State of New Mexico
Energy, Minerals and Natural Resources

SUNDRY NOTICES AND REPORTS ON WELLS (DO NOT USE THIS FORM FOR PROPOSALS TO DRILL OR TO DEEPEN OR PLUG BACK TO A DIFFERENT RESERVOIR. USE "APPLICATION FOR PERMIT" (FORM C-101) FOR SUCH PROPOSALS.)		WELL API NO. 30-015-24485
1. Type of Well: Oil Well ☐ Gas Well ☒ Other ☐		5. Indicate Type of Lease STATE ☒ FEE ☐
2. Name of Operator Maverick Permian LLC		6. State Oil & Gas Lease No.
3. Address of Operator 1000 Main Street Ste 2900 Houston, TX 77002		7. Lease Name or Unit Agreement Name ILLINOIS CAMP A COM
4. Well Location Unit Letter E : 1980 feet from the North line and 990 feet from the West line Section 5 18S Township 28E Range NMPM County		8. Well Number 001
11. Elevation (Show whether DR, RKB, RT, GR, etc.) 2654		9. OGRID Number 331199
		10. Pool name or Wildcat

(LDIM) ILLINOIS CAMP-A 000001
P&A Procedure

Maverick Permian LLC
Illinois Camp-A 000001
API# 30-015-24485

PROPOSED WBD
5/26/2025

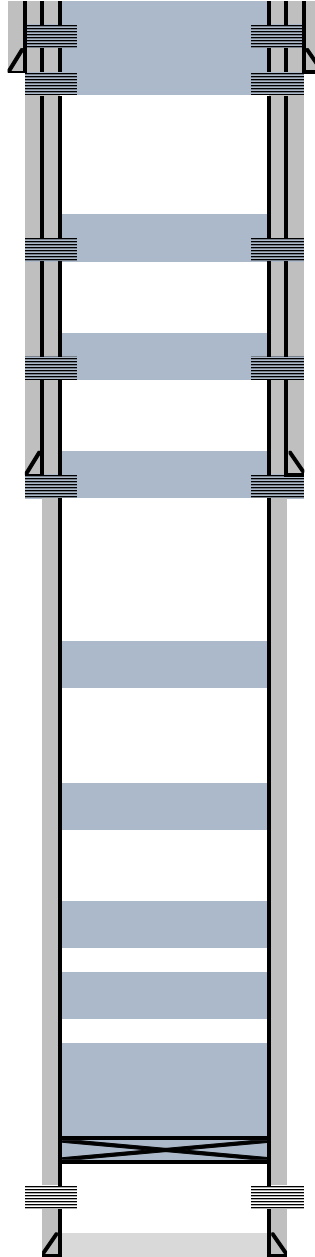
MUST BE PLUGGED BY 5/15/26

11. **Strawn Plug:**
Spot 25 sx Class H cement plug at 9,299'. WOC 4 hrs. Tag at 9,099' or higher. Record cement plug top.
12. **Cisco Plug:** **Spot 25 sx cmt 8680 - 8480' - T Canyon**
Spot 25 sx Class H cement plug at 8,252'. WOC 4 hrs. Tag at 8,052' or higher. Record cement plug top.
